INDESIT company

Model type:
AQSF109EU/HA

Commercial code:
F050599

n4008f00: Thermic link wire removed on three-phase motor

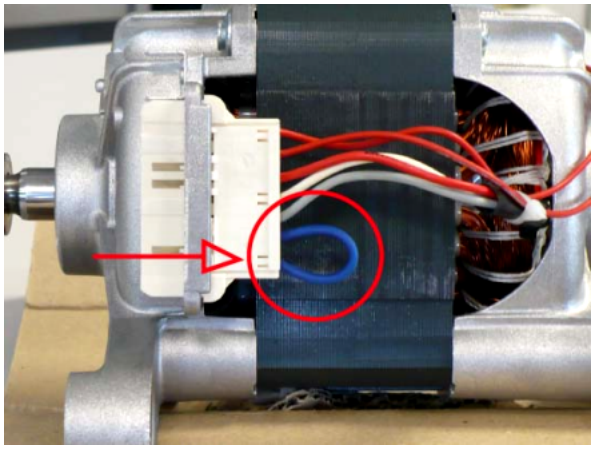
Attention!

When you assist the premodification models using the new motor code you MUST use the thermic link wire code C00265838.

The spare part warehouses will manage the premodification motor until the end of the stock, after they will be replaced with new ones and thermic link wire.

In the attached image you can see the fixing of thermic link wire in the motor therminal box.

TRIPHASE P40 46 L – INOX TUB
C00265827 new motor without thermic link wire - C00116103 premodification motor with thermic link wire

TRIPHASE P40 46 L – PLASTIC TUB
C00265826 new motor without thermic link wire - C00142390 premodification motor with thermic link wire

TRIPHASE P50 52 L
C00265829 new motor without thermic link wire - C00142205 premodification motor with thermic link wire

TRIPHASE P32 46 L TOP LOADING
C00265832 new motor without thermic link wire - C00262375 premodification motor with thermic link wire

TRIPHASE P40 46 L TOP LOADING
C00265834 nuovo new motor without thermic link wire - C00112739 premodification motor with thermic link wire
